**Fraser Planning Commission Agenda
City Council Chambers
33000 Garfield, Fraser, MI 48026
Wednesday, December 4, 2024 @ 7:00 p.m.**

Site Plan Review Summary

Site Plan Dated 11/01/2024
City of Fraser, Michigan

The site plans were updated in accordance with the review comments from McKENNA (October 7, 2024) and from Anderson, Eckstein & Westrick, Inc. (AEW) (October 29, 2024) provided as part of the planning commission agenda packet. The comments and responses are summarized below to the items that were identified requiring a response or revision. Items noted to be compliant may not be referenced in this letter.

MISTER CAR WASH
STORE # MI 1454 FRASER
SITE PLANS
LAYOUT PLAN

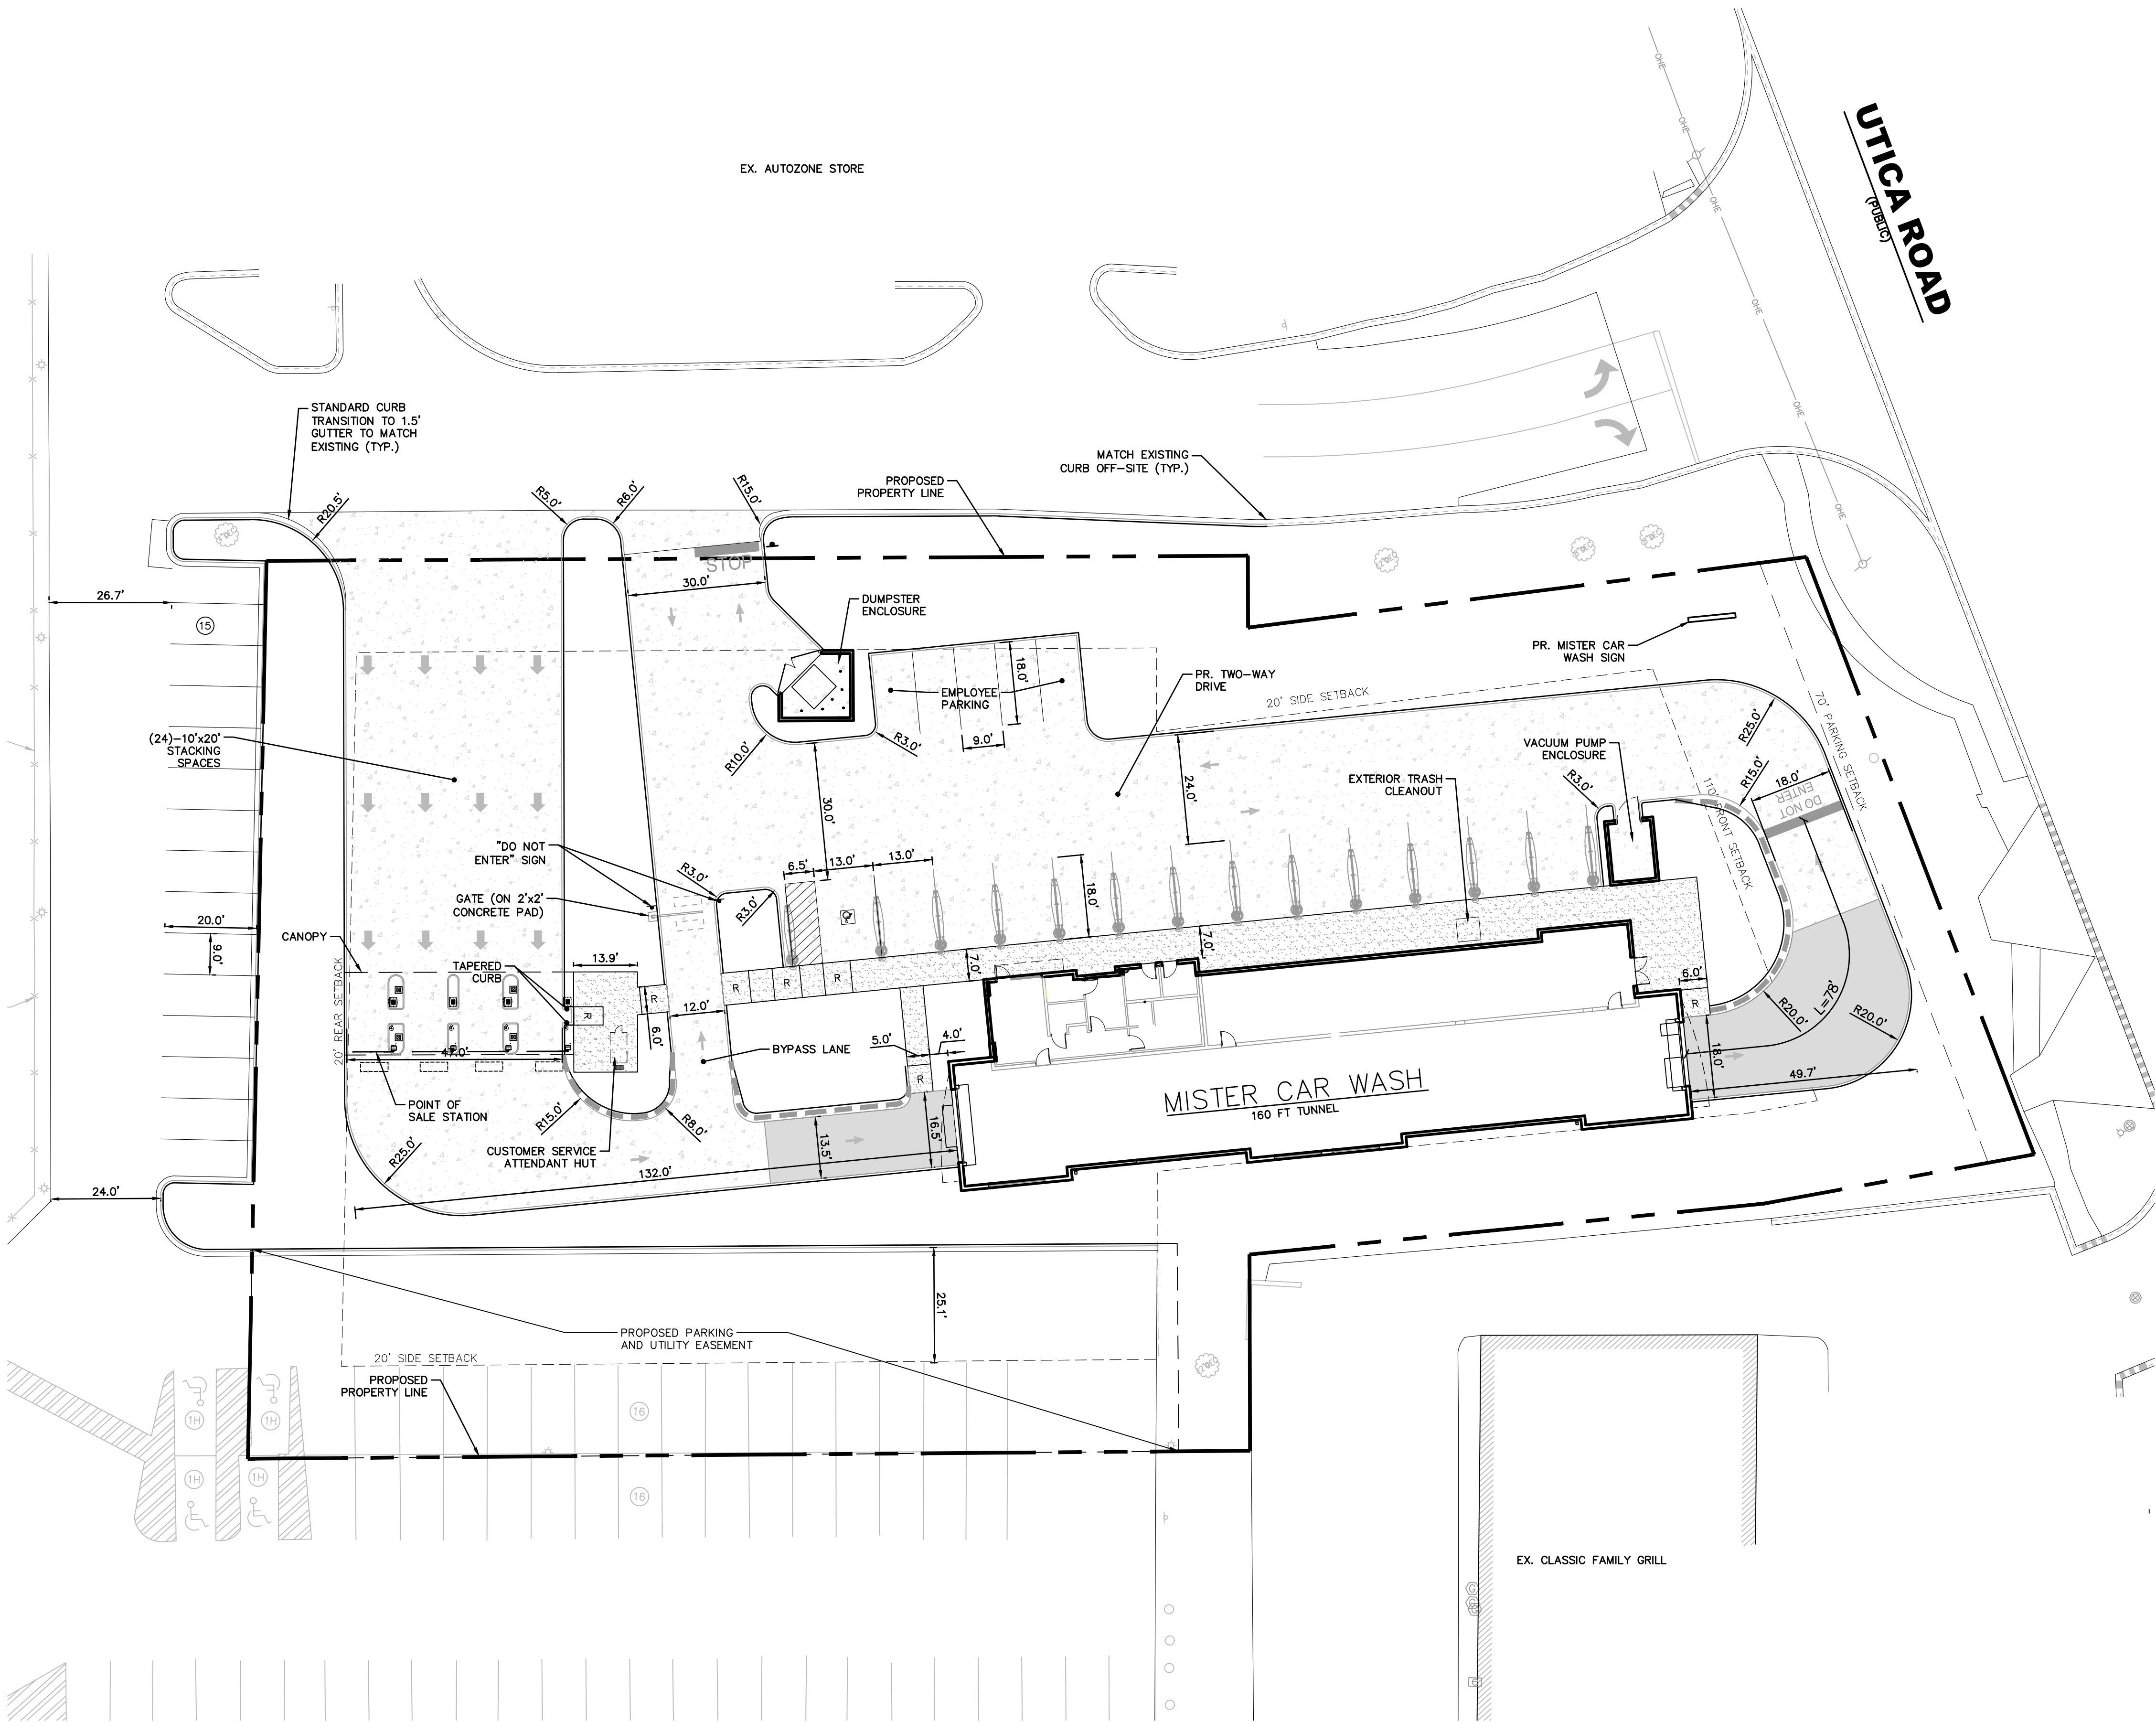
****We note the parking calculations to not appear to count the vacuum stalls as parking. Additionally, there appear to be discrepancies between the calculations provided and the site plan. For example, they indicate providing 4 employee spaces, but show 5 on the site plan.***

The site plan indicates 9x18 feet stalls for employees, and 13x18 feet stalls for the vacuum parking stalls, with a 24-foot maneuvering lane. **The applicant shall revise the parking stall lengths to comply with one of the listed parking patterns in Sec. 32-94(2).** RESPONSE: The plans have been revised to show 9' x 18' parking stalls with a 7' sidewalk or 2' of free space, allowing for a 2' overhang.

The proposed plan shows one point of ingress that is 47 feet wide. The second point of ingress and egress (east driveway) is not dimensioned. **We defer to the applicant to provide this dimension, which must be at least 30 feet wide.** RESPONSE: The site plan has been revised to show a 30' wide secondary driveway.

RESPONSE: Dimensions have been added to sheet #02 to show compliance with the 50' ft drying lane.

This is not a concern because they are meeting the minimum required still but should be corrected. RESPONSE: The vacuum stalls have not been counted towards the required count. The plans have been revised to reflect 5 employee parking spaces.

MISTER CAR WASH
STORE # MI 1454 FRASER
SITE PLANS
PRELIMINARY GRADING PLAN

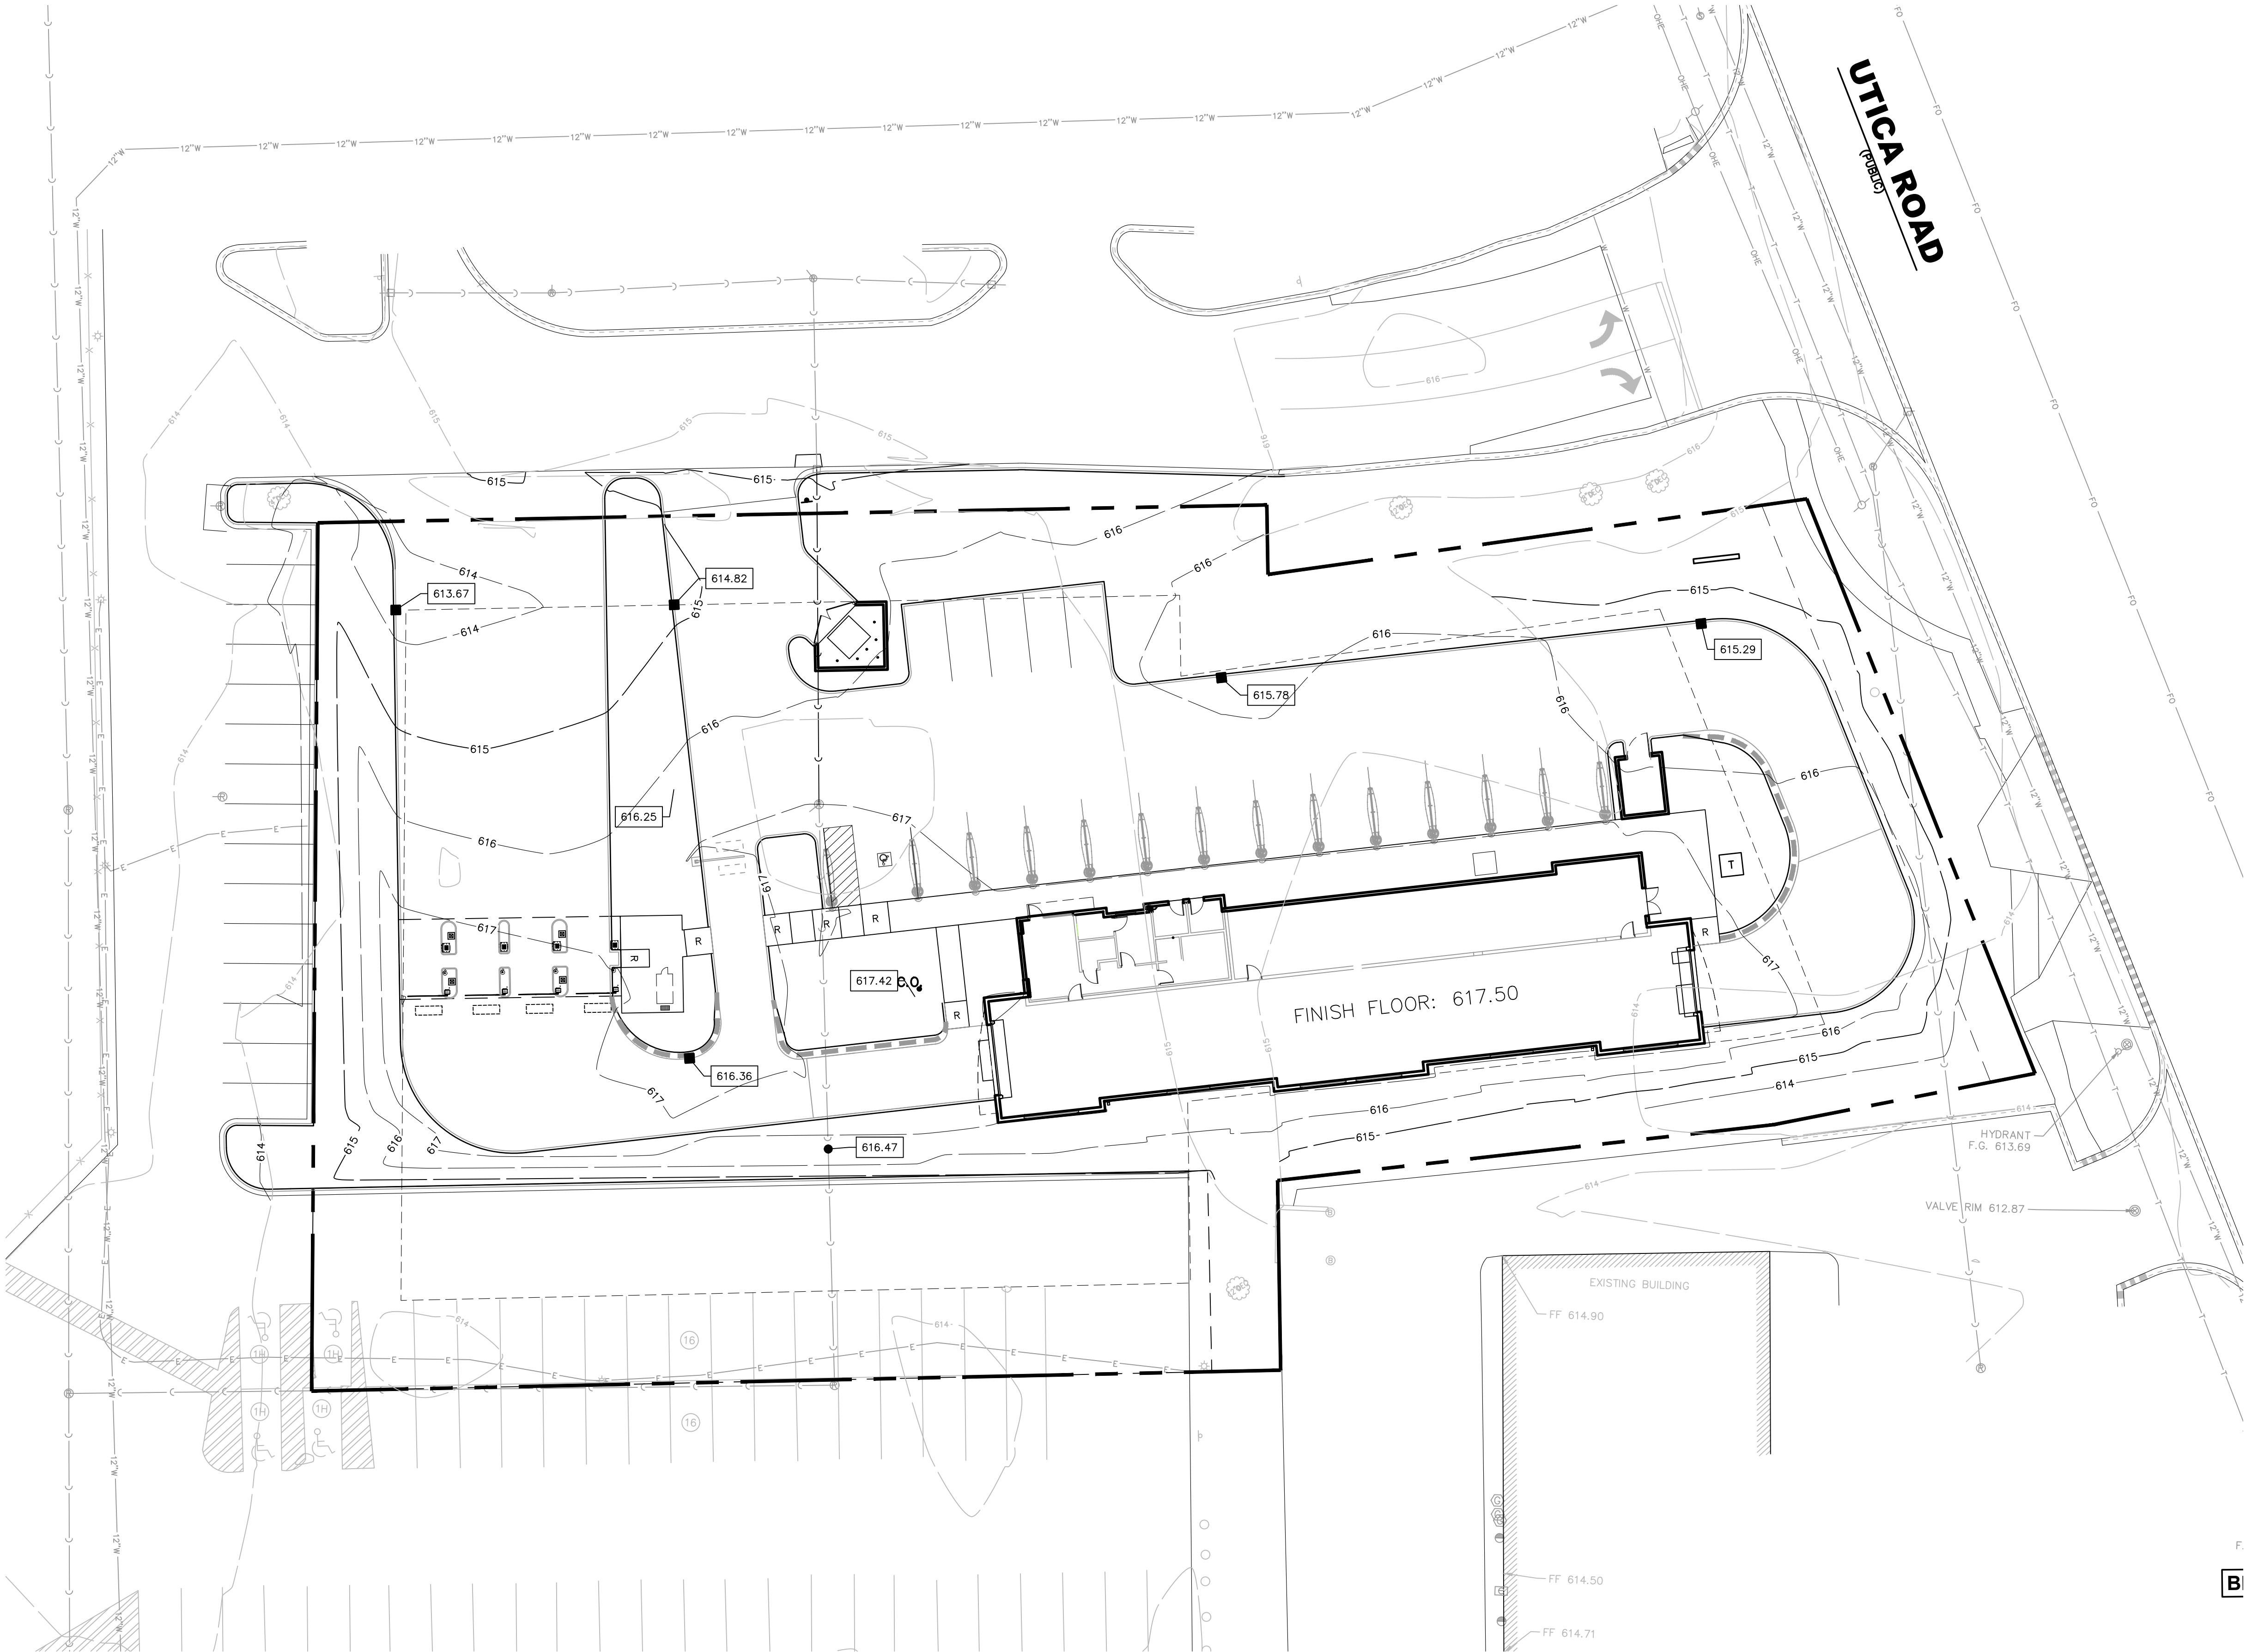
3. An ADA compliant pedestrian access route shall be provided from the public right-of-way to the building. **RESPONSE: Noted**
4. Preliminary grading plan suggests that surface drainage is directed off-site. Surface run-off shall be maintained on-site to the extent feasible. This can be reviewed during engineering phase. **RESPONSE: Noted**
